END OF ADDENDUM NUMBER ONE (1)

CIVIL PLANS	
CCD PROJECT	23043.10
DATE ISSUED	August 6, 2024
DATE REVISED	August 15, 2024
#	1

CLINTON PARKS - PHASE I
 CITY OF CLINTON
 TRACEWAY PARKS & KIDS TOWNE PARK

DRAWING NO. M101 R1

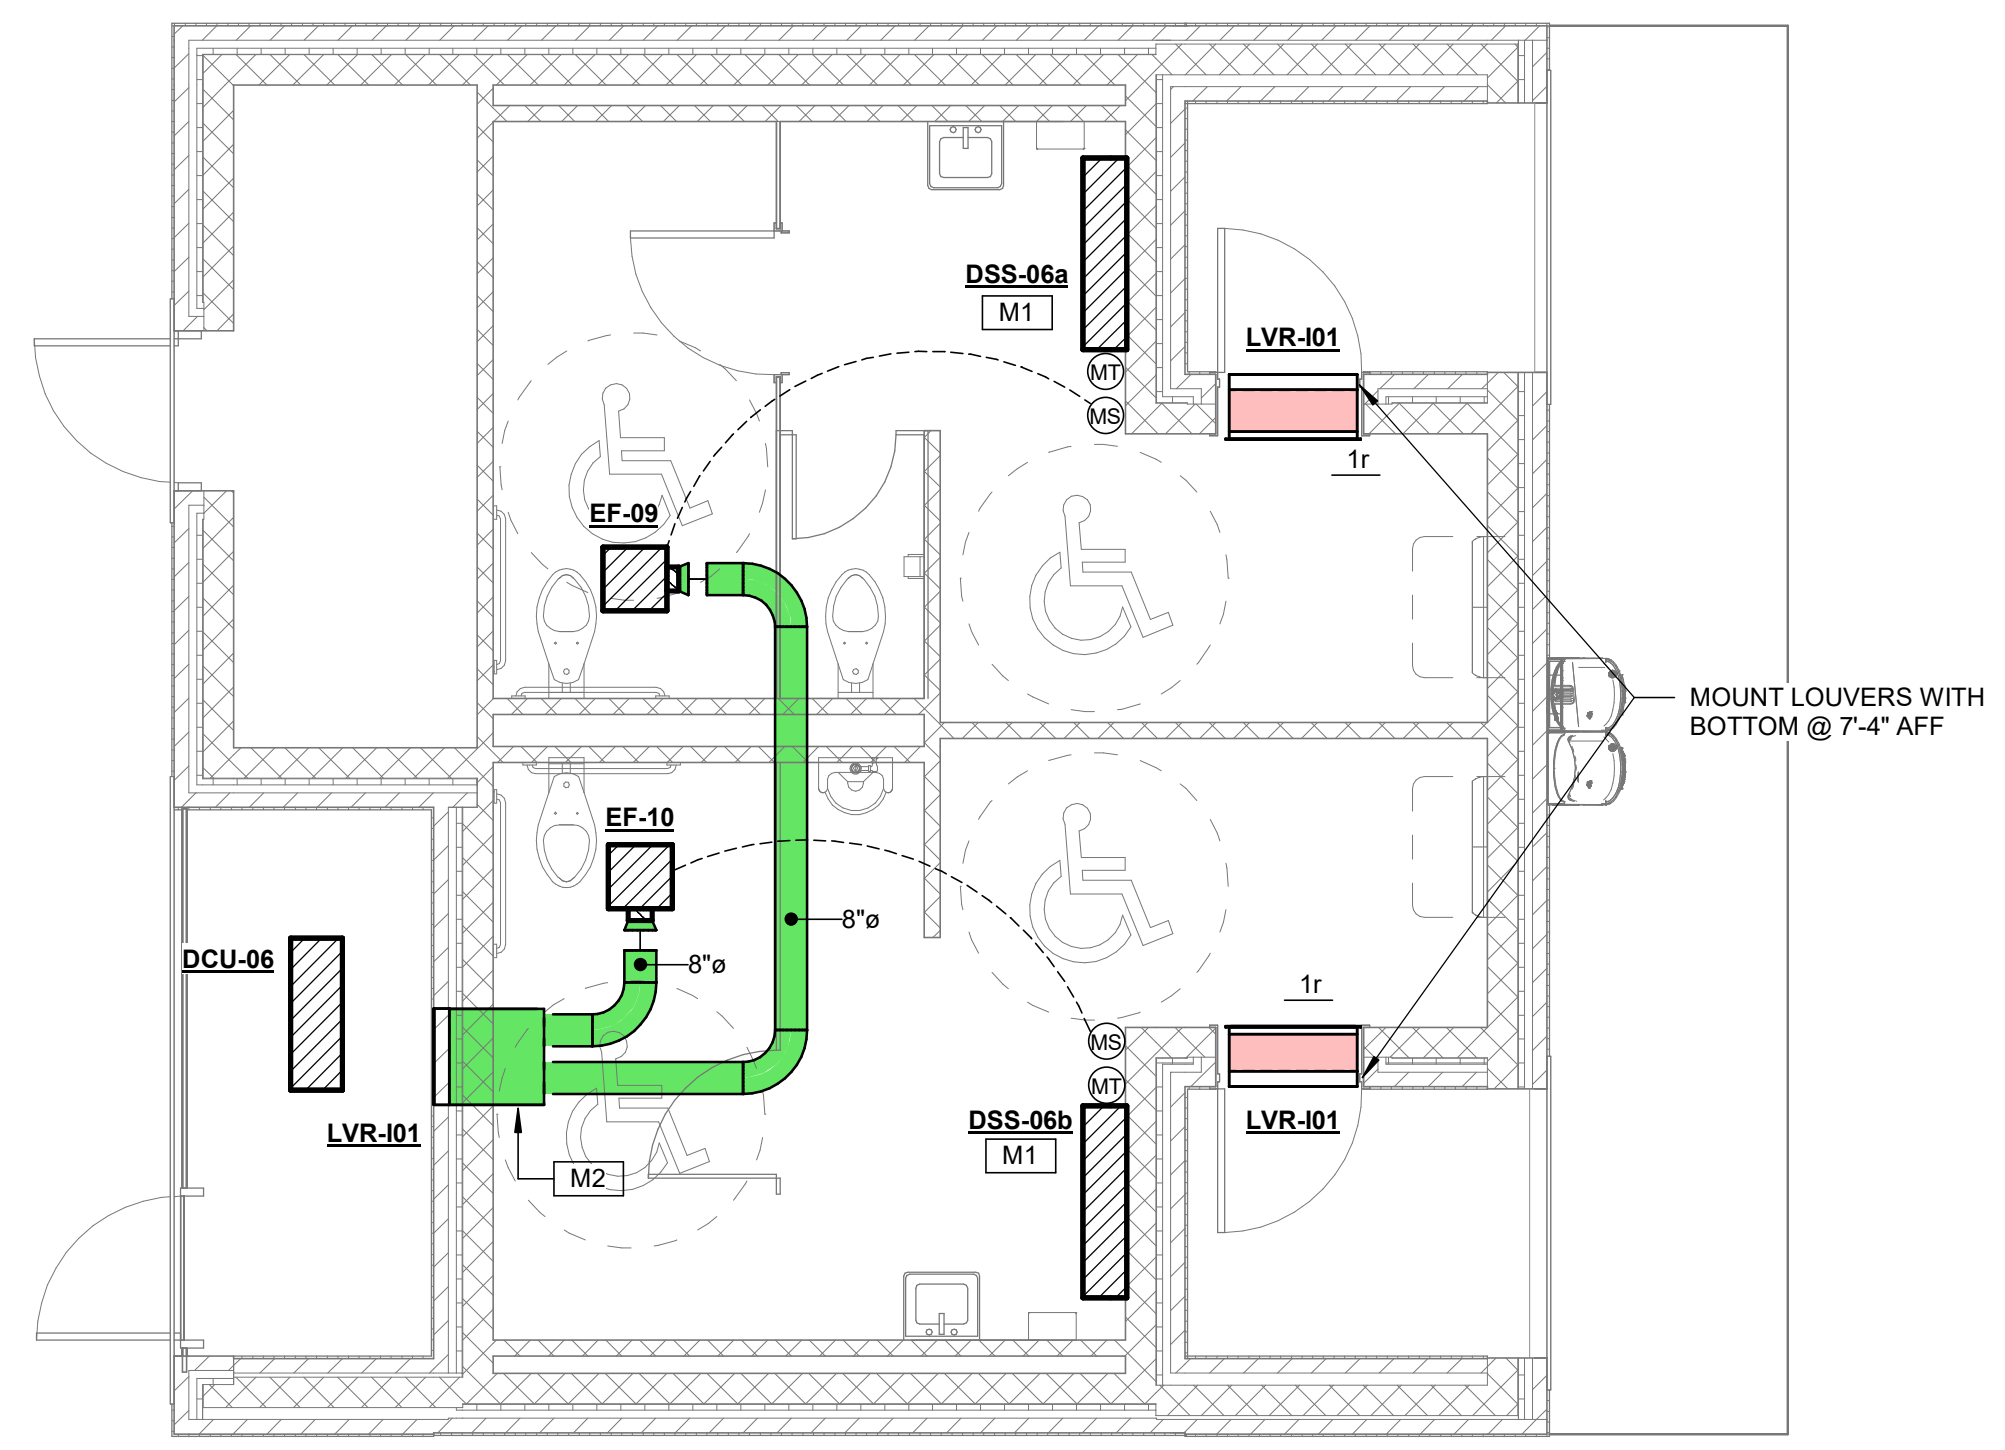
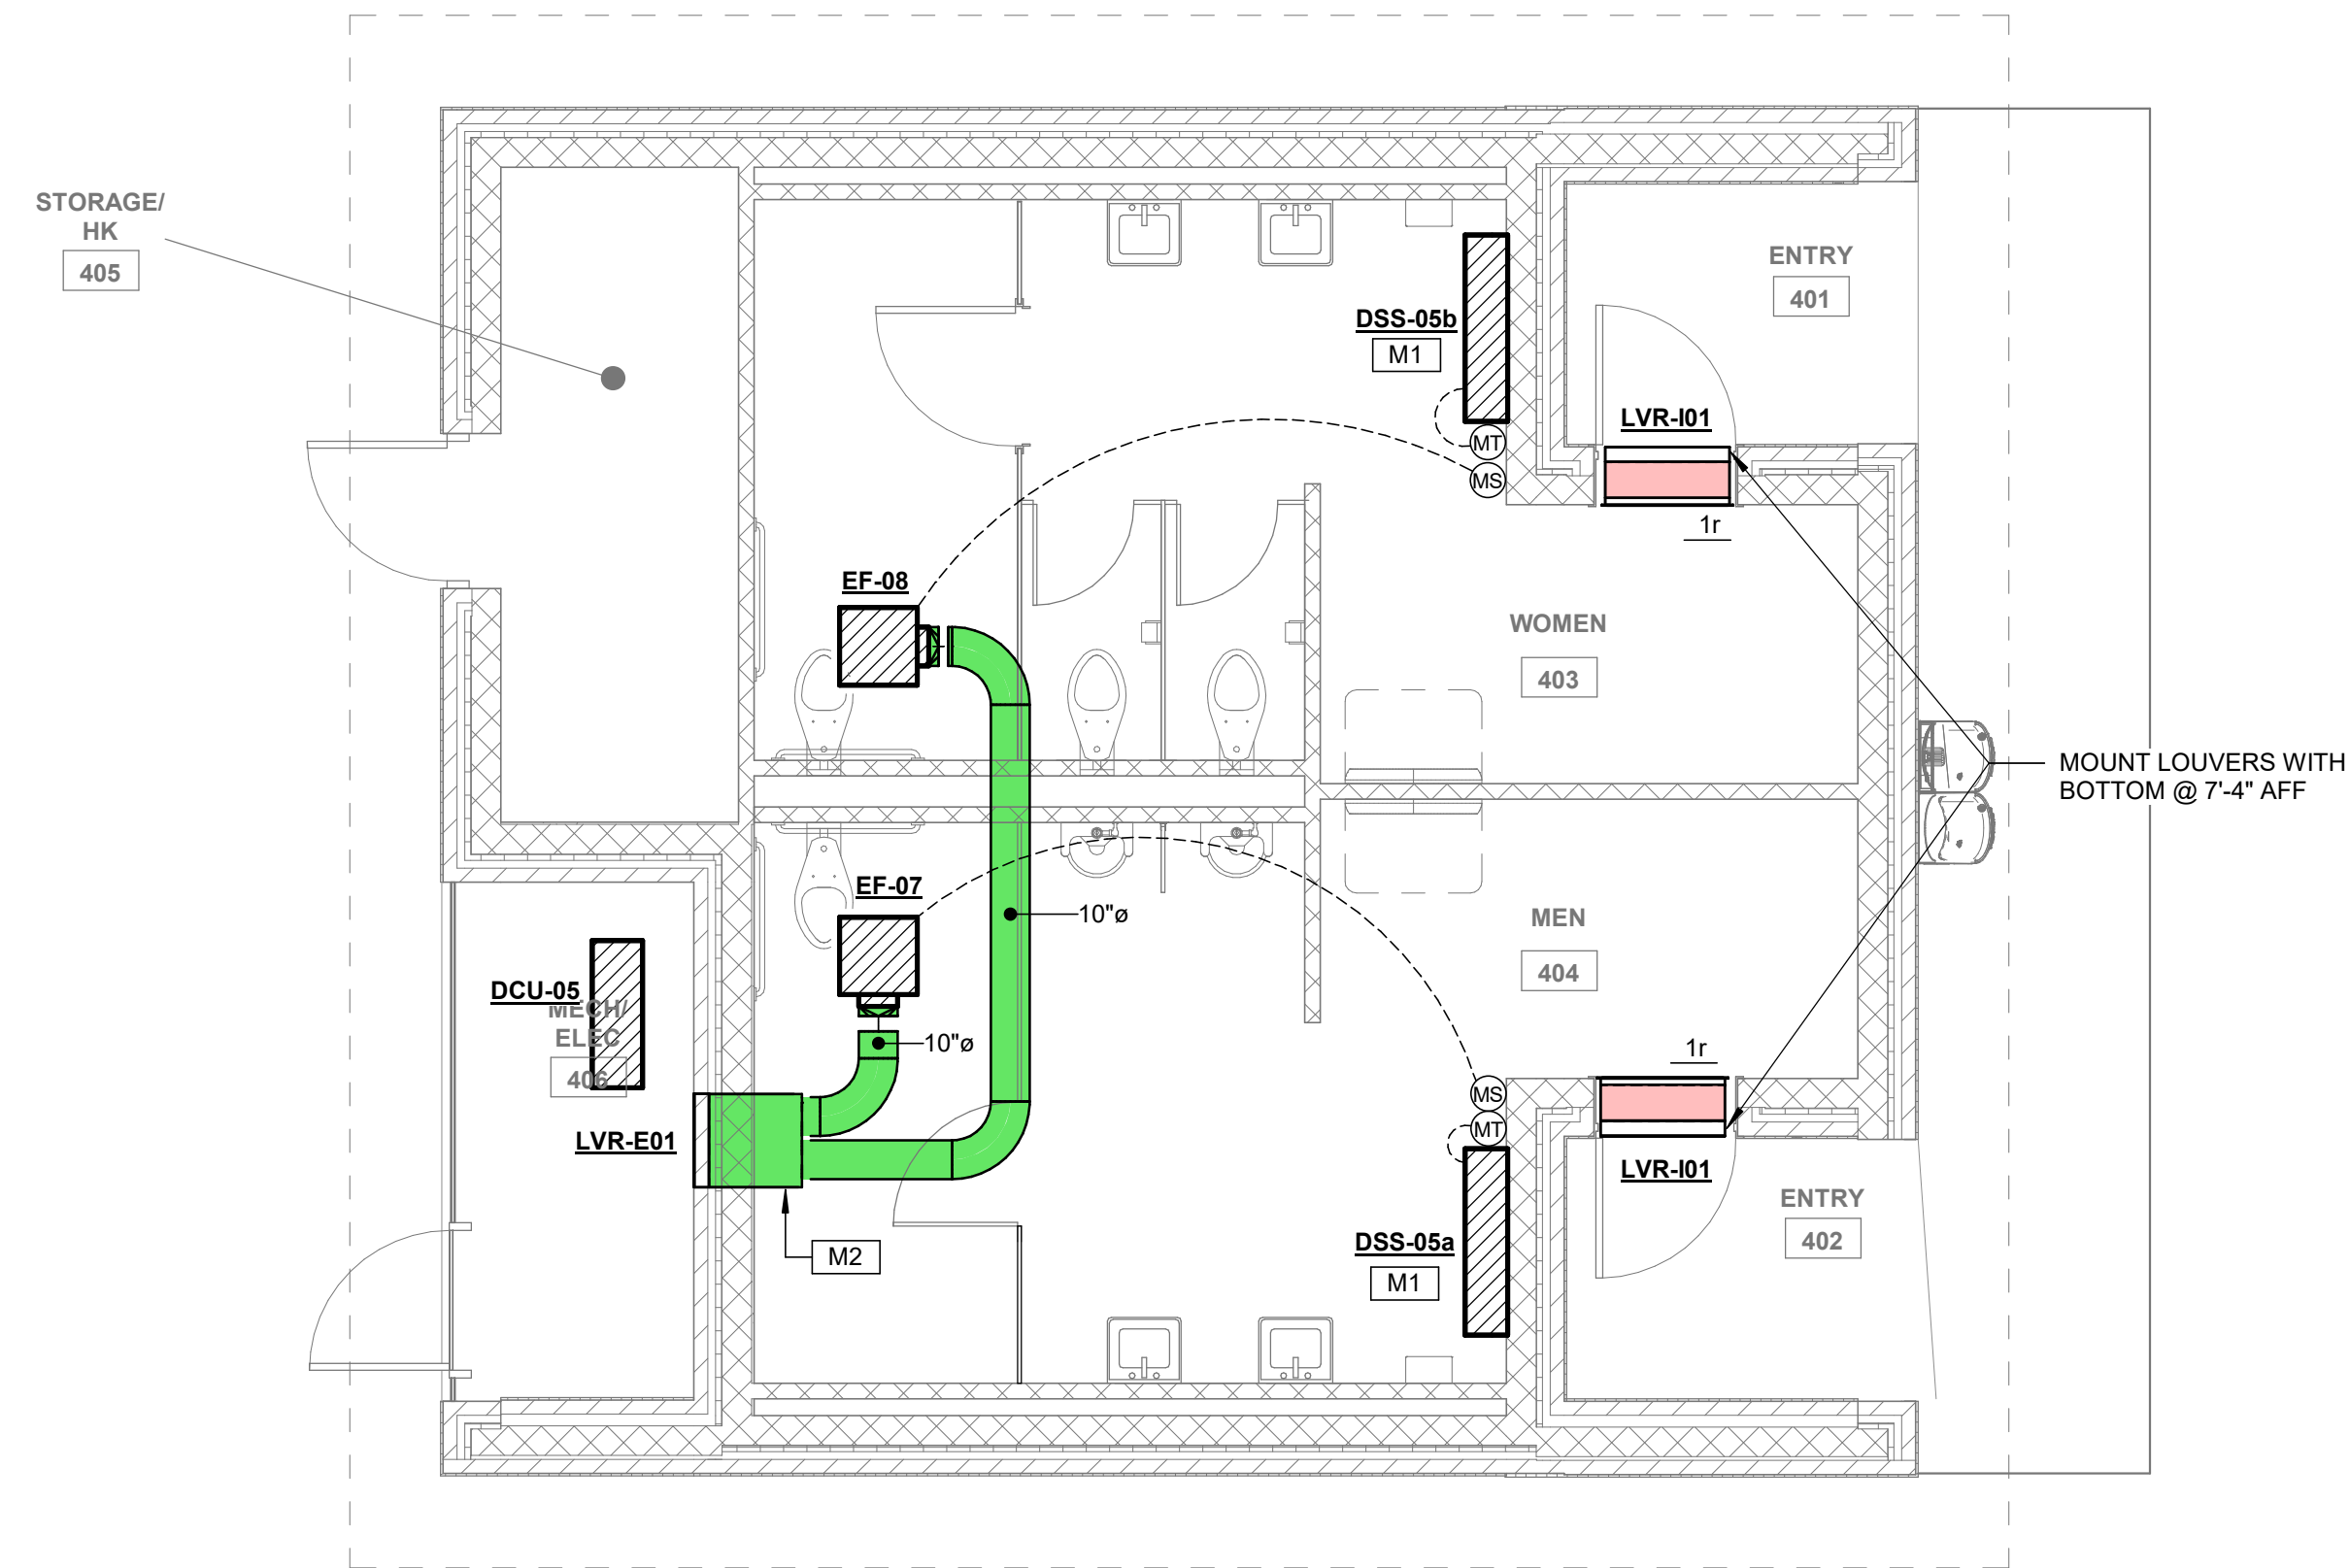
18. **DRAWING M101 HVAC, PLANS** – Replace with attached M101 R1 dated as revised August 15, 2024.
